Subject: Sywest Industrial Building EIR and Staff Report

Sywest Industrial Building 907 South Kellogg Avenue, Goleta APN Number: 071-190-035

Case No. 17-121-DP-DRB; 20-0004-ORD; 22-0003-ORD; 23-0002-ORD.

RE: <u>Planning Commission April 28, 2025, Meeting – Agenda Item B.1</u> <u>Sywest Industrial Building Project (Case No. 17-121-DP) –</u> <u>Final Environmental Impact Report (SCH# 2023040690)</u>

Figure 1. Actual and predicted relationships between the numbers of vertebrate wildlife species detected and the elapsed survey time based on our visual-scan survey on 21 April 2025.

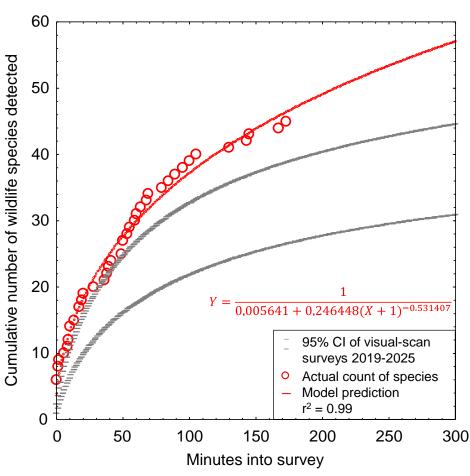
The species of wildlife we detected at the project site comprised only a sampling of the species that were present during our survey. To demonstrate this, I fit a nonlinear regression model to our cumulative number of vertebrate species detected with time into our survey to predict the number of species that we would have detected with a longer survey or perhaps with additional biologists available to assist. The model is a logistic growth model which reaches an asymptote that corresponds with the maximum number of vertebrate wildlife species that could have been detected during the survey. In this case, the model fit to our survey data predicts many more species of vertebrate wildlife were available to be detected during our survey (Figure 1).

We do not know which species we missed, but the pattern in our data indicates a greater than average use of the project site compared to six evening surveys at other sites we have completed in the region (Figure 1). Importantly, however, the species we did and did not detect on 21 April composed only a fraction of the species that would occur at the project site over the period of a year or longer. This is because it is easy to miss species that are cryptic in nature, or occur only seasonally as they migrate, or whose members visit the site only periodically while patrolling large home ranges, such as did the white-tailed kite we detected.

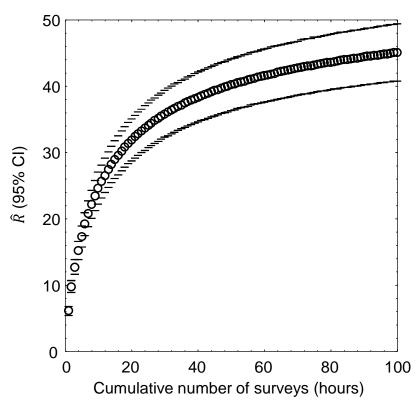
I projected the predictions of each model to thousands of hours to find predicted asymptotes of wildlife species richness. The mean model-predicted asymptote of species richness was 57 after 11,857 hours of visual-scan surveys among the 46 stations of my research site. I also averaged model predictions of species richness at each incremental increase of number of surveys, i.e., number of hours (Figure 2). On average I would have detected 14.2 species over my first 3.58 hours of surveys at my research site in the Altamont Pass (3.58 hours to match the 3.58 hours we surveyed at the project site), which composed 24.9% of the predicted total number of species I would detect with a much larger survey effort at the research site. Given the example illustrated in Figure 2, the 45 species we detected after our 3.58 hours of diurnal survey at the project site likely represented 24.9% of the species to be detected after many more visual-scan surveys over another year or longer. With many more repeat surveys through the year, we would likely detect $^{45}/_{0.249}$ = 181 species of vertebrate wildlife at the site. Assuming our ratio of special-status to non-special-status species was to hold through the detections of all 181 predicted diurnally-active species, then continued surveys would eventually detect 28 special-status species of diurnally-active vertebrate wildlife.

Because my prediction of 181 species of vertebrate wildlife, including 28 special-status species of vertebrate wildlife, is derived from daytime visual-scan surveys, and would detect few nocturnal mammals such as bats, the true number of species composing the wildlife community of the site must be larger. In fact, we know it is larger, because we performed a nocturnal survey as well. In little more than 1.5 hours of acoustic detection survey for bats, we detected five species of bats in more than 220 foraging passes. At 140 foraging passes per hour, our survey result was the busiest we have ever detected during a bat survey, the second busiest having been another project site in Goleta. Our rate of

Figure 3. Actual and model-predicted relationship between the number of bat species detected and the elapsed survey time based on our acoustic detection survey on 21 April 2025.

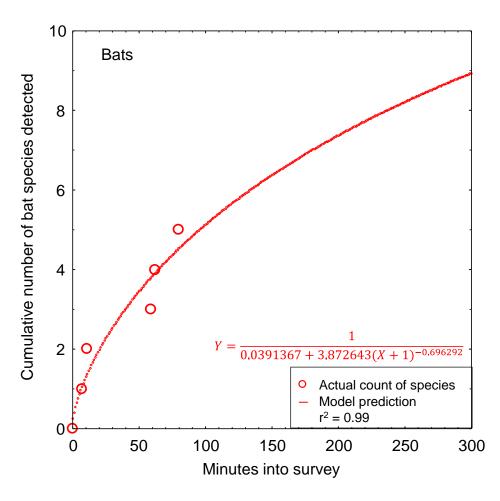
The pattern in the rate of bat species detections suggests that we would have detected nine species of bats within five hours had we continued to survey that long (Figure 3). (We did not commit to five hours because we had another survey to complete at a distant location in the early morning.) The bat species we managed to detect included Mexican free-tailed bat, California myotis, Yuma myotis, silver-haired bat, and spotted bat, whose sonograms are their signatures (Figure 4). The spotted bat is one of the rarest species of bat on the West Coast, and it is a California Species of Special Concern. We detected it twice.

Photo 27. Google Earth image of project site in February 2025, showing more vegetation than asphalt surface.

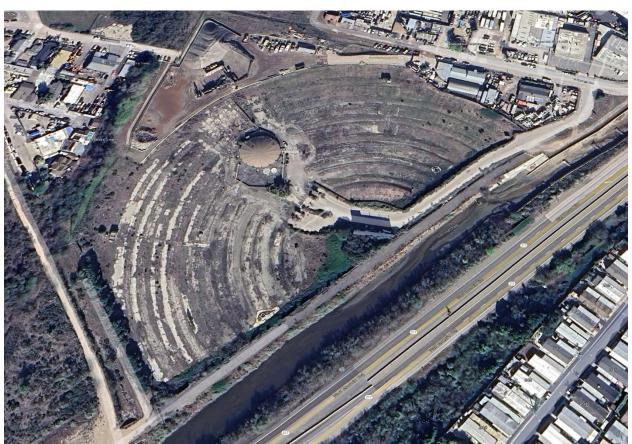
The characterization of the environmental setting is too old to be accurate anymore. The conclusions of Tierney (2017) are based on surveys that were completed eight years ago. Tierney's (2017: Figure 5, especially #3) photo depictions of the site are outdated, as the site is now largely covered by ruderal vegetation rather than bare pavement (Photo 27).

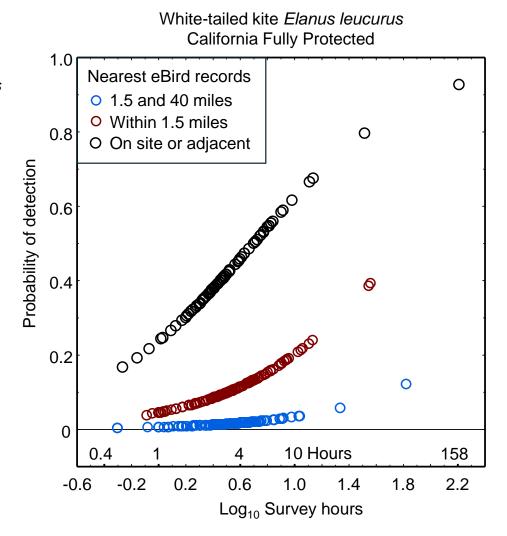
Accurate characterization of the existing environmental setting is an essential foundation for analysis of potential project impacts, but the FEIR mischaracterizes the existing environmental setting as its foundation for impacts analysis related to plants and wildlife. An impacts analysis should consider whether and how the proposed project would affect members of each potentially occurring special-status species. In the following, I analyze several types of impacts likely to result from the project, none of which is adequately analyzed in the FEIR.
